**Engineering Statement
Prepared for the City of Madison
Re:
Proposed U.S. Cellular Site #782514
979 Jonathon Drive
Madison, WI 53713**

Application for CUP

February 1, 2010

Figure 1 - Propagation Map Without Proposed Site

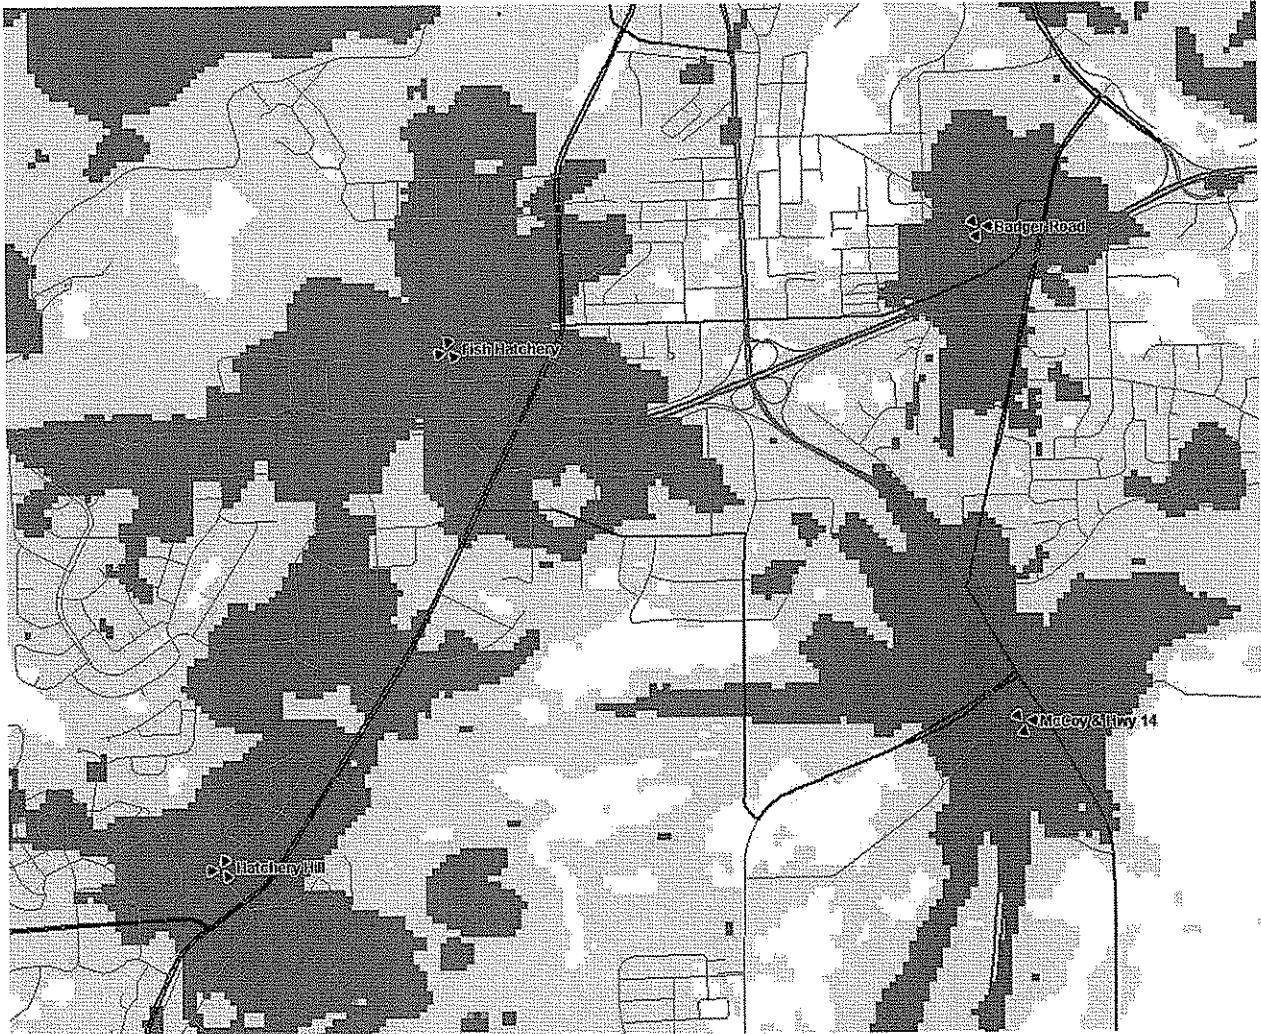
A propagation study conducted by U.S. Cellular, and verified by this engineer, shows that there is an unmistakable in-building coverage void south of the Beltline Highway, between Fish Hatchery Road and Highway 14, as seen in “yellow” in attached Figure 1. This coverage gap results in no connection, reduced quality or dropped calls in this area. A “green” level of service is necessary for reliable wireless service in industrial buildings.

Figure 2 – Propagation Map with Proposed Site

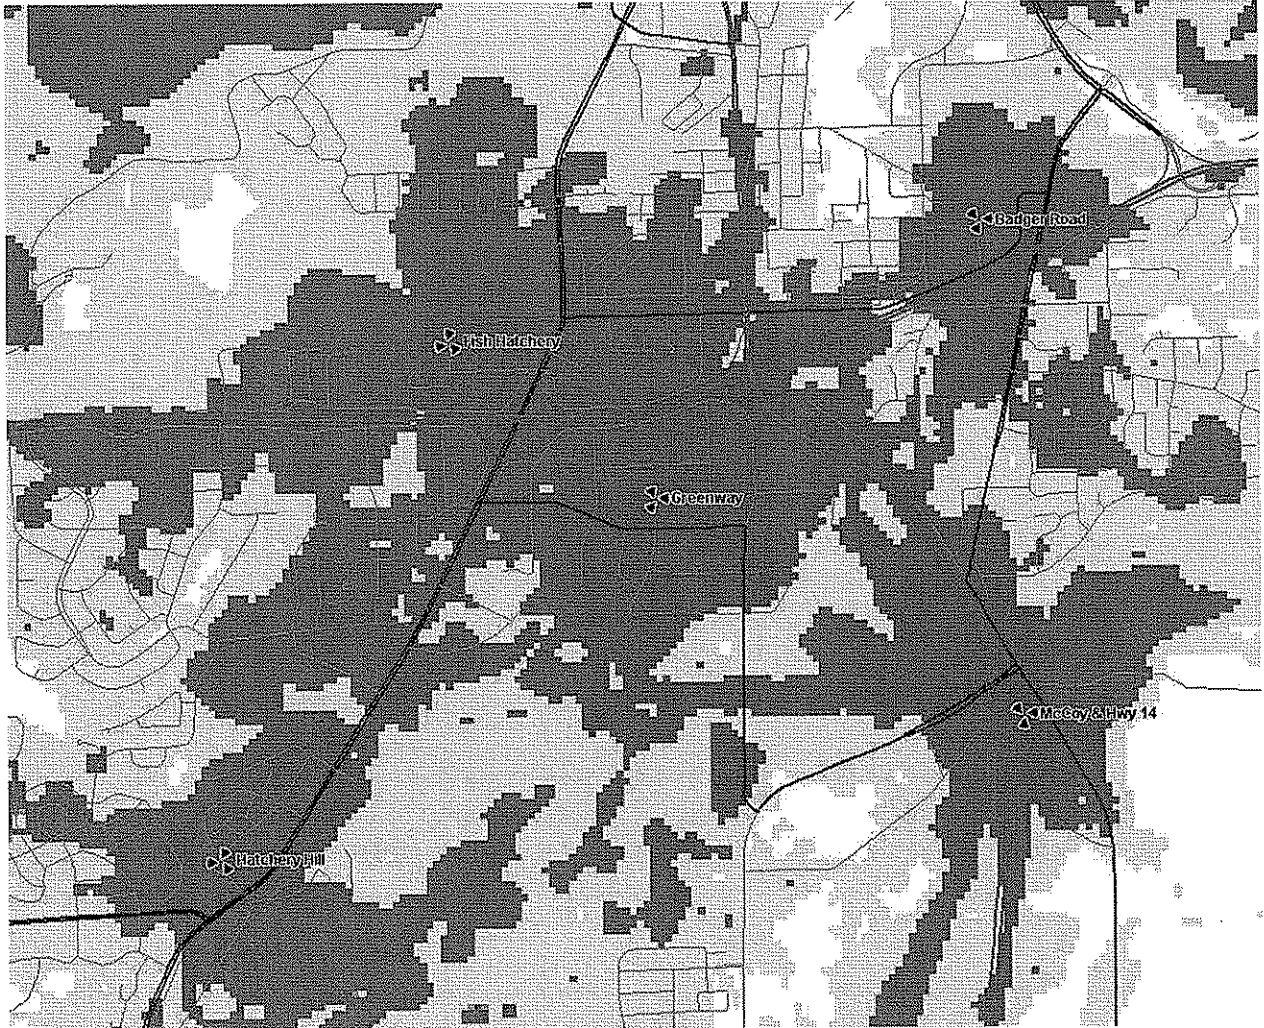
Figure 2 shows a coverage areas map with the proposed site activated. The proposed U.S. Cellular site is well situated and will provide good service in the Greenway area, which is currently lacking in coverage.

Figure 3 – Site Search Ring

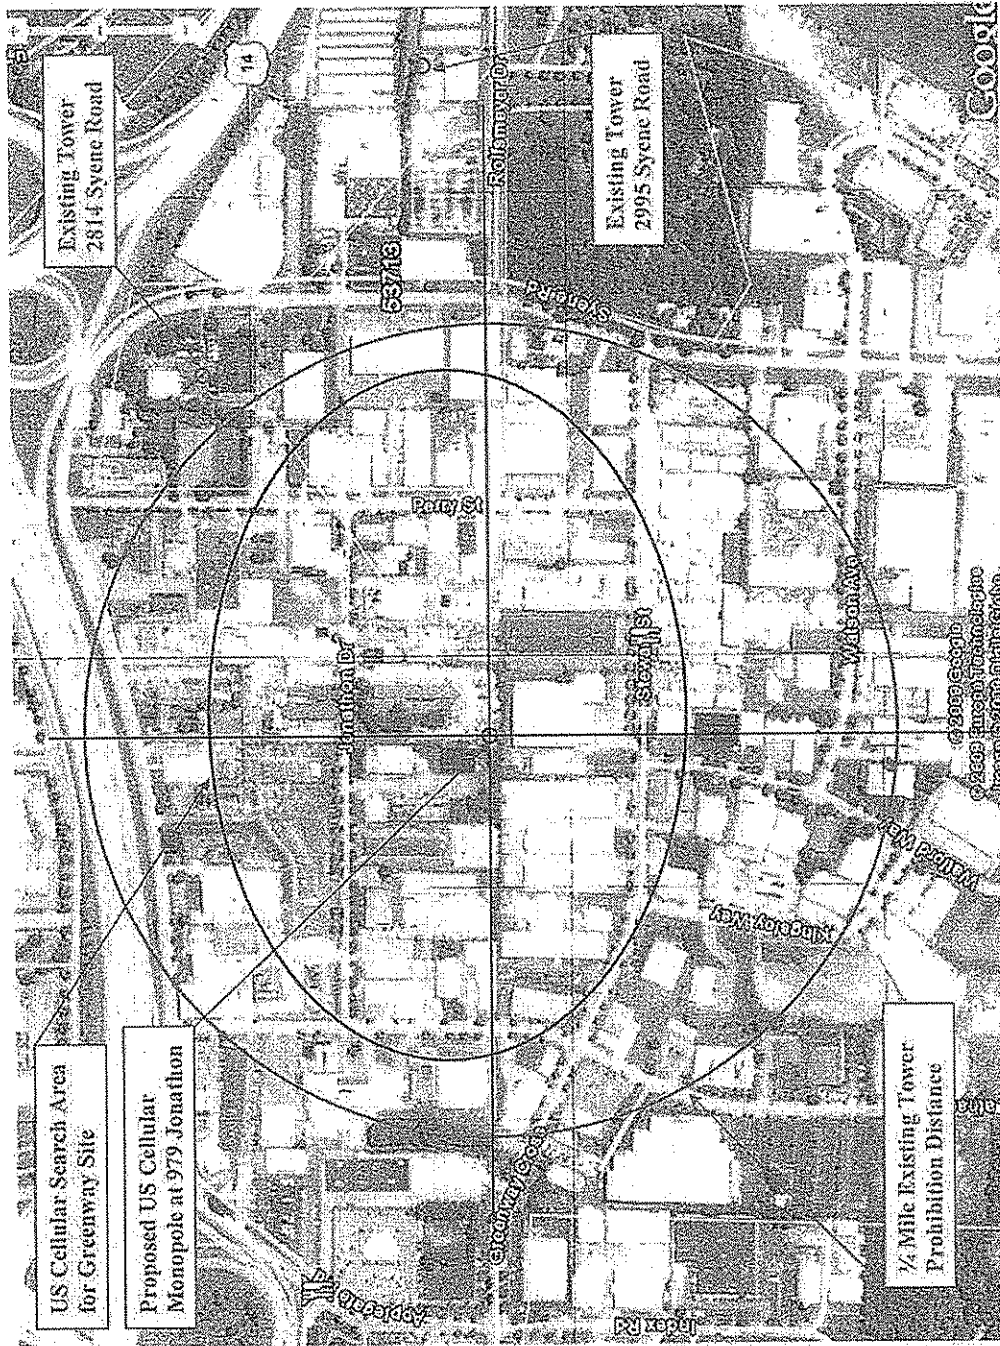
The attached Figure 3 shows the site "search ring" within which a new base station tower should be located in order to address the service problems described in Section II of this report. The proposed Greenway site is well within this search ring. According to the applicant, and as confirmed by database searches performed by this office, there were no other towers within ¼ mile of the proposed site.
